PROJECT: Church Street Pedestrian Plaza

OWNER: City of Anderson
401 South Main Street
Anderson, SC 29625

PROJECT #: 1244

ADDENDUM NO. 1 – August 5, 2026

SITE PLAN

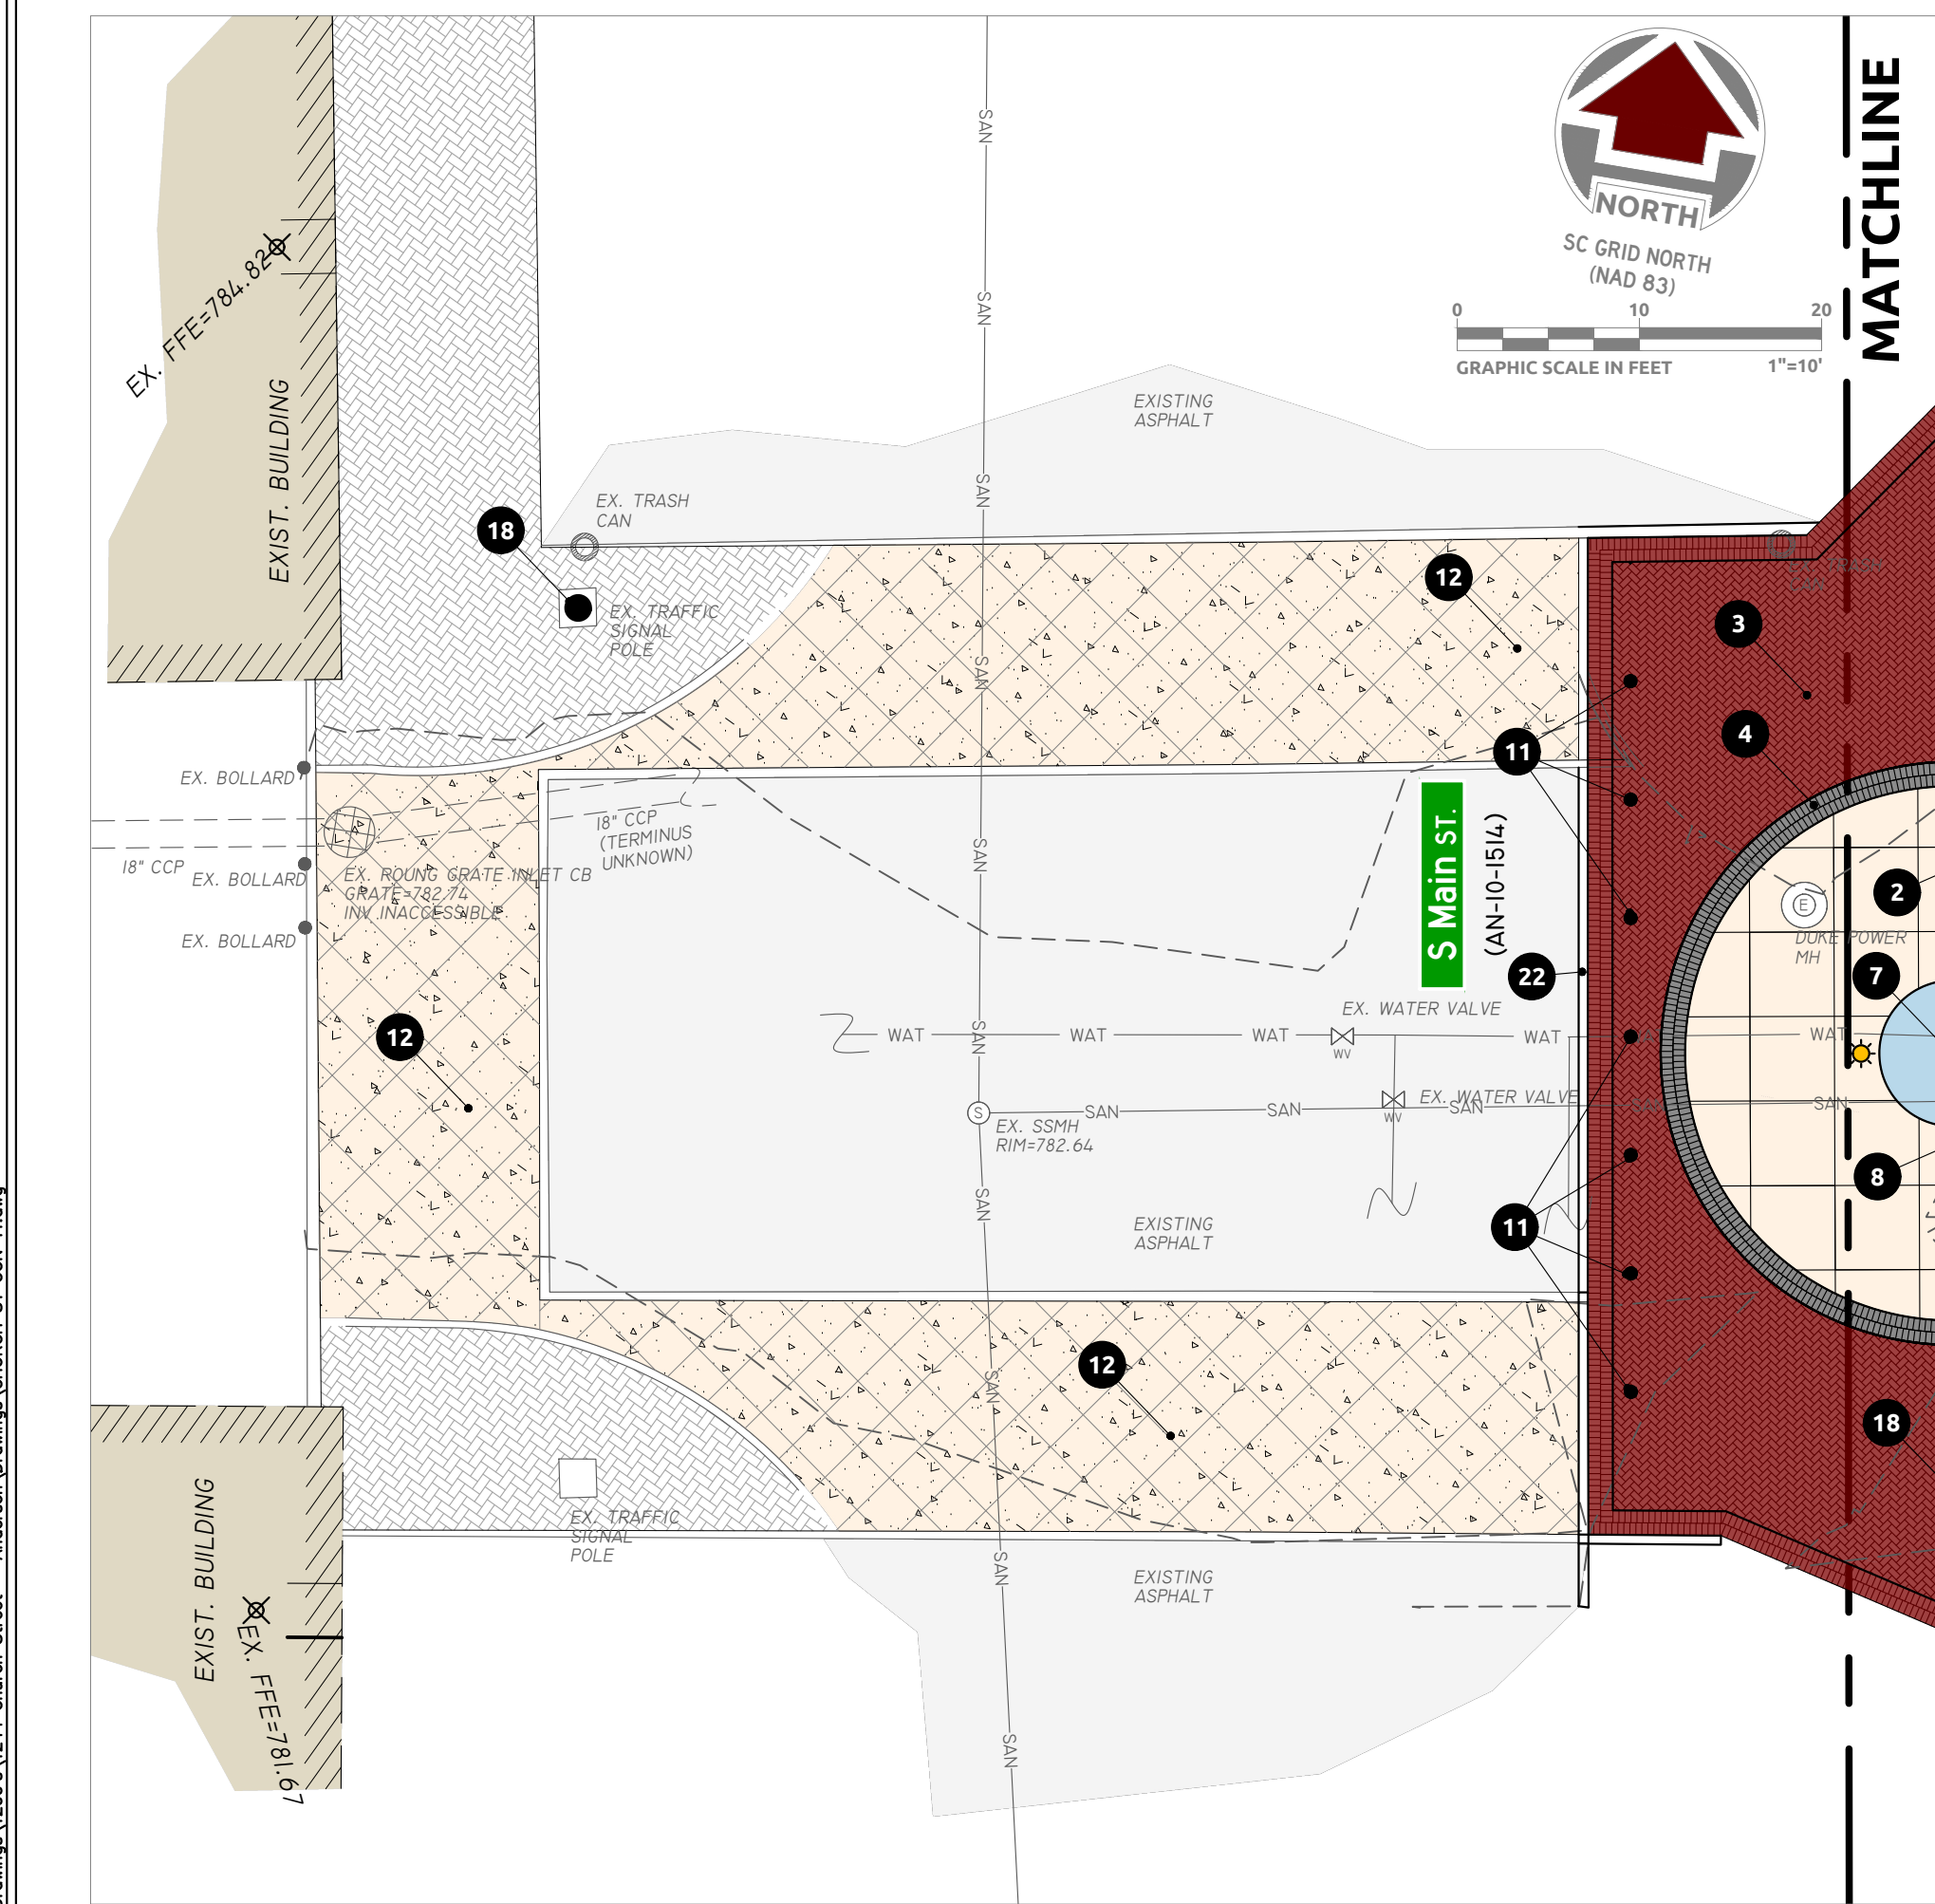
4. Can you please provide electrical drawings?
Electrical is to be Design Build by Contractor.
5. Drawing C200 and notes 3-5 indicate brick pavers to be by Endicott Clay Products. However, Specification section 02614 calls out Pine Hall Pathway Red. Please clarify which is correct. Other portions of this spec section indicated wall and column brick, but no wall or column work was found on drawings. please clarify.
Pavers are to be as specified on Sheet C200.

6. Site note 9 on C200 states provide decorative posts to match the ones at Caters Lake Park. Please provide a manufacture and model and height. Or provide an allowance for all bidders.
An allowance will be provided as part of Addendum No. 1.

11. I would like to request an addendum removing the (3) concrete crosswalks at Church Street and Main. They are currently under an existing contract that we have with the city to be replaced. We will already have these replaced by the time this project gets started. I would propose that the demo for your project start at LINE-ITEM #22 Flush Granite Curb.

- DECORATIVE POSTS MATCH DECORATIVE POSTS AT CATER'S LAKE PARK, ANDERSON, SC.) WITH CATENARY (STRING) LIGHTING. DUAL OUTLET RECEPTACLES TO BE AT BASE OF 4 OF THE 12 POSTS AS SHOWN ON THE DRAWING WITH * SYMBOL. CATENARY LIGHTING TO BE STERLING LIGHTING, CAFE LIGHT KIT, S14 12V LED BULB, 24" SPACING BETWEEN LIGHTS. STRING LIGHTS TO BE HUNG ON CABLES RUNNING POST TO POST. TRANSFORMER TO BE ~~4'x8'x2-1/4" THICK WIRECUT BRICK PAVEMENT WITH SPACING LUG BY ENDICOTT CLAY PRODUCTS COMPANY, FAIRBURY, NEBRASKA, OR EQUAL. DARK BRICK BORDER PAVERS SHALL BE NO. 46 MANGANESE IRONSPOT. INTERIOR FIELD BRICK PAVERS SHALL BE 4"x8"x2-1/4" THICK WIRE CUT BRICK PAVEMENT WITH SPACING LUG BY ENDICOTT CLAY PRODUCTS COMPANY, NO. 46 MANGANESE IRONSPOT.~~ **900W PRO, STAINLESS STEEL WITH PHOTOCELL, OR APPROVED EQUAL CONTRACTOR TO PROVIDE SHOP DRAWINGS. COORDINATE ELECTRIC SERVICE CONNECTIONS WITH DUKE ENERGY & CITY OF ANDERSON.**

The Bid Form has been revised and is included in this Addendum No. 1. The west end limits of demolition shall begin at Line Item #22 Flush Granite Curb.
